STAFF REPORT

PLANNING & ZONING COMMISSION

Village Green Municipal Building, Council Chambers
47 Hall Street
Wednesday, June 13, 2018
7:00 P.M.

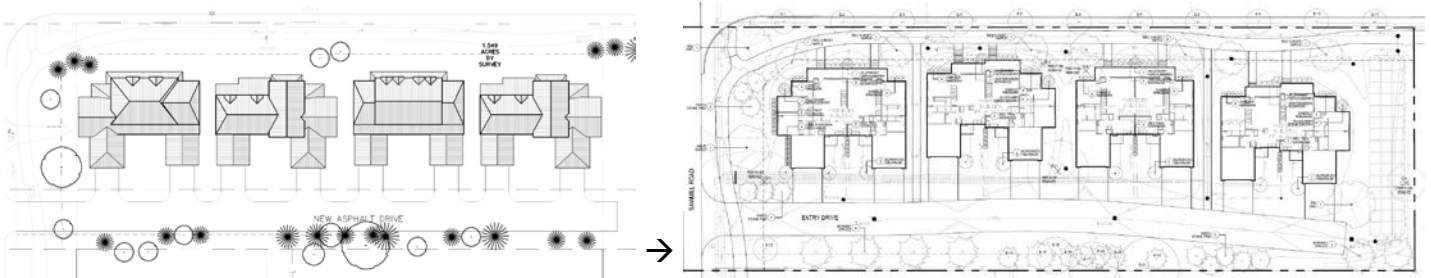
1. Project now named Mews at Zion.
2. A new site plan showing the location of the proposed buildings.
3. New elevations and material selections for each building (see image below – not to scale).

4. At staff's request, the middle two buildings were moved closer to the pathway and the roadway was curved to match the buildings to soften the look and feel of the site as well as to save the trees in the rear.

Staff is pleased with the revised site plan, number of units, and elevations presented. Furthermore, staff commends the applicant for following staff's comments and suggestions in order to create a proposal that is much more in line with P&Z's comments.

1. The applicant meet with the Commons' HOA.
2. Staff, P&Z, and Chris Meyer's comments are addressed before submitting for the preliminary plan review.

IMAGE 1

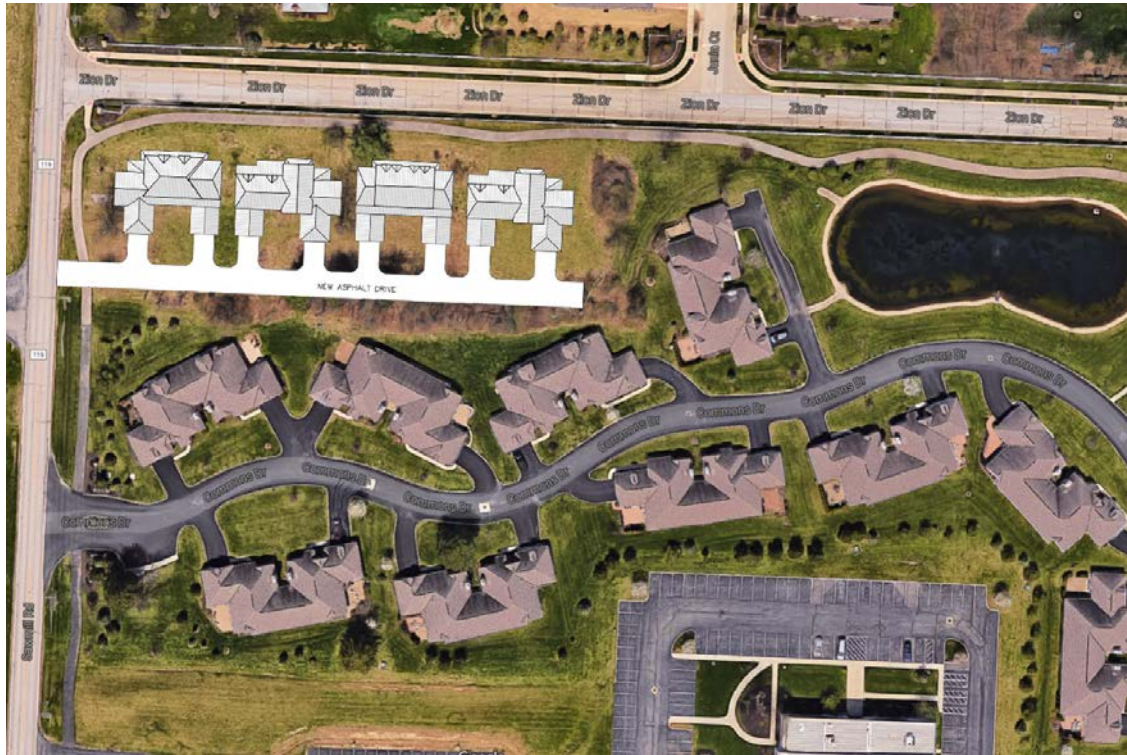
Staff is pleased with the revised site plan, number of units, and elevations presented. Furthermore, staff commends the applicant for following staff's comments and suggestions in order to create a proposal that is much more in line with P&Z's comments.

Other items to consider are the density, scale of buildings, architecture, effect on roadways, and impacts on schools. Overall, the development addresses each of these concerns. One, this new proposal of 5.26 dwelling units per acre (du/ac) is within the densities allowable in the Planned Residence District (PR), which is 9 du/ac. The proposed density of 5.26 du/ac is higher than the 2.98 du/ac of The Commons of Powell to the south. However, a higher density development on a corner parcel is acceptable, and possibly beneficial as a barrier between the road and the less dense existing development. Two, the development is of similar scale to the buildings to the south and as a result, will blend into its surroundings better. Three, the new architecture is of high quality, which helps to be in-line with city's Comprehensive Plan calls for. Furthermore, the fine architecture which is somewhat of a "farm-style" aesthetic would further improve a piece of the city. Lastly, the total 8 units will be geared to empty-nesters and retirees. In turn, they will have little impact of roadways and schools since the users of these type of units have fewer car trips and children than single family homes. As a result, staff does not consider any potential negative traffic impact generated by the proposed development.

1. All Engineering Department comments are addressed before the next submission.
